# UNITED STATES PATENT AND TRADEMARK OFFICE

APPLICATION NO.	FILING DATE	FIRST NAMED INVENTOR	ATTORNEY DOCKET NO.	CONFIRMATION NO.
10/565,893	09/22/2006	Shaun Patrick Rymer	102792-518 (11296P1 US)	8060
27389	7590	03/17/2009		
NORRIS, MCLAUGHLIN & MARCUS			EXAMINER	
875 THIRD AVE			SHARPE, DANIEL T	
18TH FLOOR				
NEW YORK, NY 10022			ART UNIT	PAPER NUMBER
			3752	
			MAIL DATE	DELIVERY MODE
			03/17/2009 PAPER

### Office Action Summary

## DETAILED ACTION

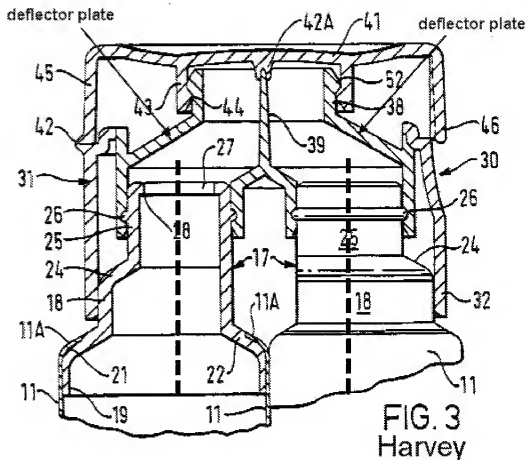
Regarding claim 1: Harvey discloses a bottle having two reservoirs (11), a separate passageway from each reservoir, each passageway opening to the atmosphere (when the cap is removed as in figure 5), a deflector plate (39) between the openings, in contact with at least one of the liquid streams, the openings arranged so

that the liquid streams are caused to be deflected towards the other stream causing the streams to mix once they have passed the deflector plate.

Regarding claim 5: Each passageway has its own deflector plate as illustrated in examiner generated figure below.

Regarding claim 7: The two passageways are substantially parallel as shown by the dotted line in the examiner generated figure below.
